**Work Order ID 81578**

Parent Item Name: Basket Hoop

| DRAWING NO.<br>D3166 | TITLE<br>BASKET HOOP | REV A1           | DART AEROSPACE LTD<br>ENGINEERING ORDER |  | D.E.O. NO.<br>D3166-A-2 | SHEET NO.<br>1 OF 1 | SCALE<br>NTS |

1) MODIFY MATERIAL NOTE FOR D3166-1 AS SHOWN:

D3166-1 BASKET HOOP

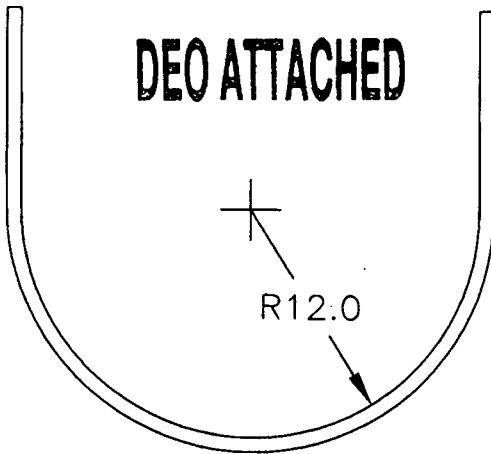
| A1               | 04.04.08       | 38+/-1 HAS 36.0                                   |                        |

10.6 (REF, NEED 8.0 MIN)

D3166-3 BASKET HOOP

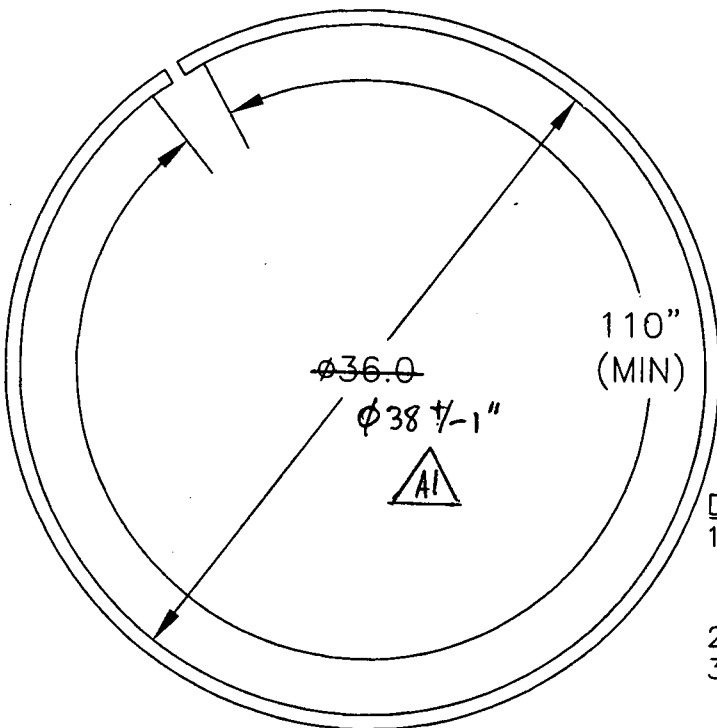
2) MODIFY MATERIAL NOTE FOR D3166-3 AS SHOWN:

- 1) MATERIAL: AISI 304/316 SS SQUARE TUBING,  
0.75" x 0.75" x 0.063 WALL, 120.00" LONG  
(REF DART SPEC. M304TS0.750W.063)

- 1) MATERIAL: AISI 304/316 SS, 3/4 X 3/4 X 0.065 WALL SQUARE TUBING,  
120.00" LONG  
REF. DART SPEC M304TS0.750W.065
